Technical BULLETIN

CERTAIN 2015 YZF-R1F and YZF-R1MF MODELS Excessive Rear View Mirror Vibration

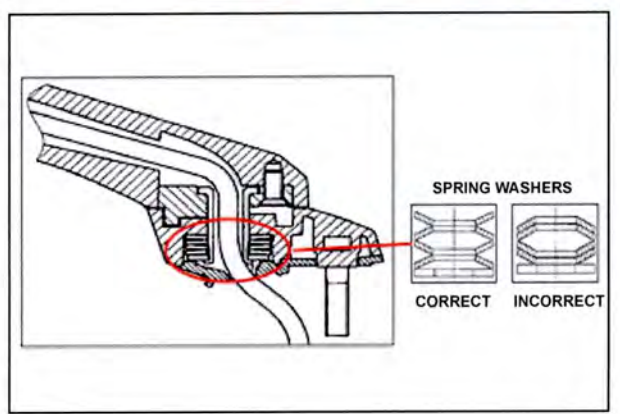
Problem: In certain units, the rider may notice excessive vibration of the rear view mirrors while riding.

Cause: The spring washers that supply tension to the pivot points in the mirrors were installed incorrectly during manufacturing. Since tension is decreased in the pivot point of the mirror, free play occurs which results in vibration.

Remedy: On units within the affected range, replace the left and right side mirrors.

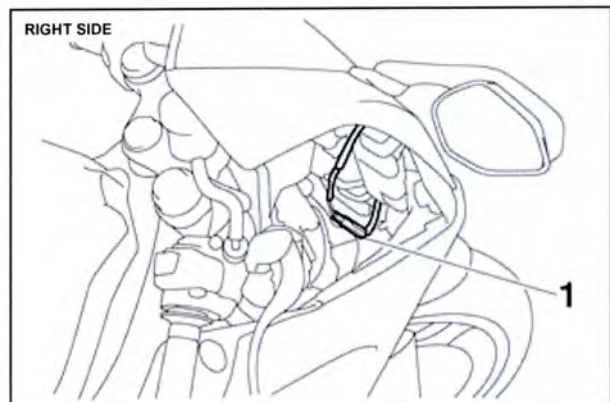
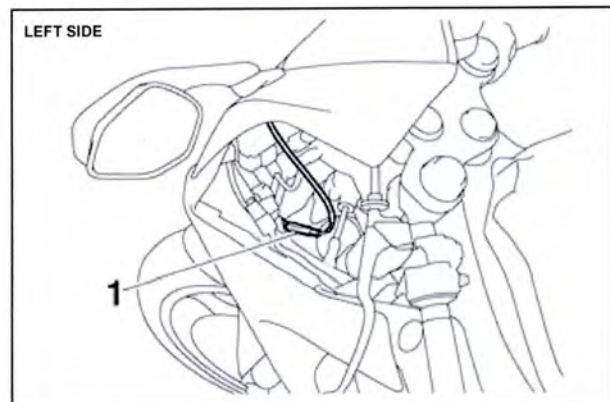
1. Remove the side panel covers and disconnect the turn signal coupler (1) for each side.

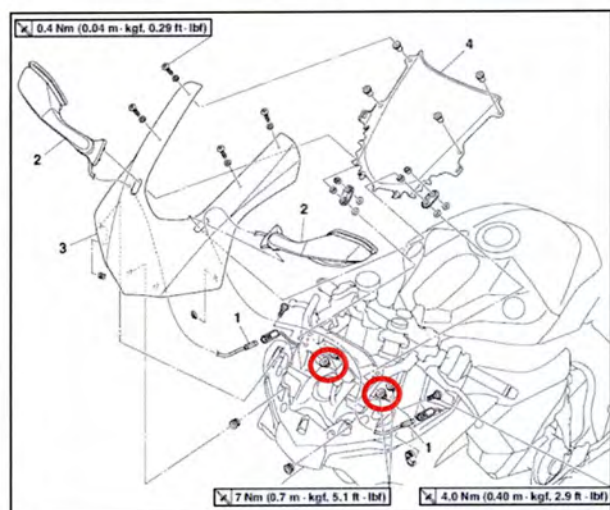
2. Remove the 2 nuts retaining each mirror and remove the mirror assembly.
3. Install the replacement mirror in the reverse order of disassembly.
